REMARKS

⁹ App'n. No. 10/689.885 filed October 21, 2003 EXPRESS MAIL EV062828622US
Amendment and Response filed February 23, 2005 in Response to Office Action of December 21, 2004
Attorney Docket No.: E0523-00018 (AU0304046)

FIG. 3a

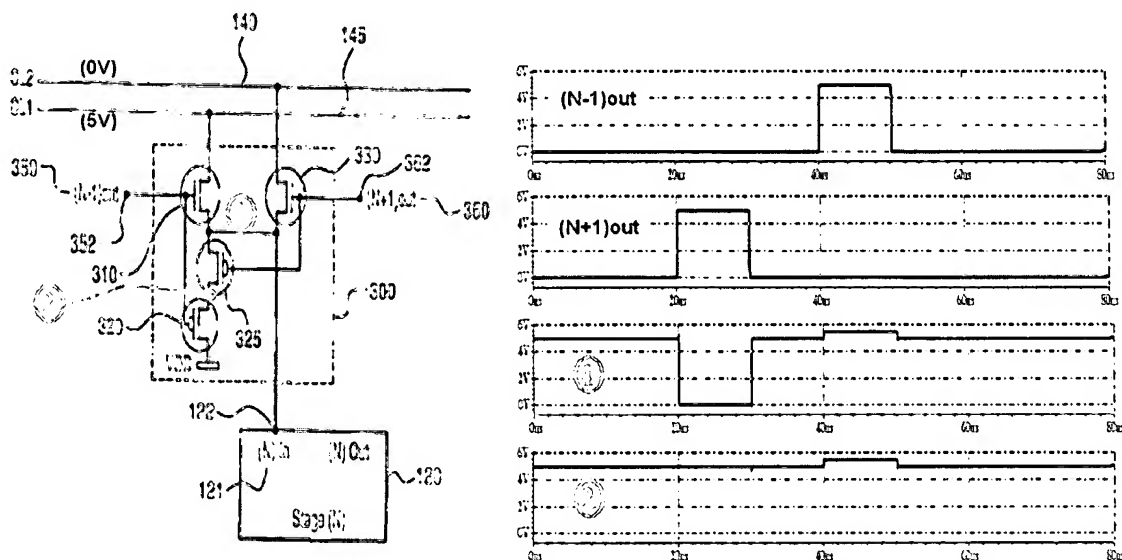
"the present claims also appear to describe structures with the same power supply connected to both the drain and source terminals of the recited transistors. More particularly, Figure 3a depicts the third power supply as being equal to V_{dd} so, for embodiments corresponding to Figure 3a, the circuit would not operate, seemingly, if the transistors having their drain source path connected to V_{dd} on one side also had the same path connected to V_{dd} on the

other side. Likewise, Figure 4a depicts an embodiment wherein the third power supply is equal to V_{ss} so, similarly, the same problem exists in terms of support for those embodiments reciting source/drain paths of transistors with both ends connected to the same power supplies. The specification does not support such hybrid embodiments nor does it disclose how it would function."

Response: At no time are all transistor drain/source paths connected at both ends to the same voltage. Control lines CL_1 145 and CL_1 140 are typically set in opposite states as described in the specification. See paragraph 21 "In the present invention CL_1 145 and CL_2 140 are set to different voltage levels . . . "; paragraph 22 "control line CL_1 145 is set to a low voltage, V_{ss} , and control line CL_2 is set to a high voltage, V_{dd} "; paragraph 25 "control line CL_1 145 is set to a high voltage, V_{dd} , and control line CL_2 140 is set to a low voltage, V_{ss} "; paragraph 29 "in this case, control line CL_1 145 is set to a high voltage, V_{dd} , and control line CL_2 140 set to a low voltage, V_{ss} "; and paragraph 31 "In this case, control line CL_1 145 is set to a low voltage, V_{ss} , and control line CL_2 140 is set to a high voltage, V_{dd} ." Thus, there is never a case where all transistors have the same voltage applied to both source and drain sides.

Further, the fact that transistor string 410, 425 and 420 (or 310, 325 and 320) might have the same voltage at the extreme ends of the string, does not preclude the transistors from functioning, since not all transistors in the string need to be on to have the proper voltage appear at the output, 122. For example, for the circuit depicted in Figure 4a, when CL_1 145 is at V_{ss} and CL_2 140 is at V_{dd} (i.e. transistor string 410, 425 and 420 connected at both ends to V_{ss}), when $(n-1)^*$ is high and $(n+1)^*$ is high, transistors 420 and 425 are on and the path from V_{ss} to output terminal 122 is complete

from Vss. With the same CL₁, CL₂ voltages when (N-1)* transitions low, the drain of transistor 410 is forced low by the gate/drain capacitance of transistor 410 because that capacitance was previously charged to 5V. That charge is sufficient to force terminal 122 low.

Finally, the applicant includes here two SPICE circuit simulations to demonstrate that the circuits do function in practice as described in the specification. The first shows the circuit output (node 1) for Figure 3a where CL_1 is high and CL_2 is low, i.e. Figure 3c. The second chart shows the circuit output for Figure 4a where CL_1 is low and CL_2 is high, i.e. Figure 4c.
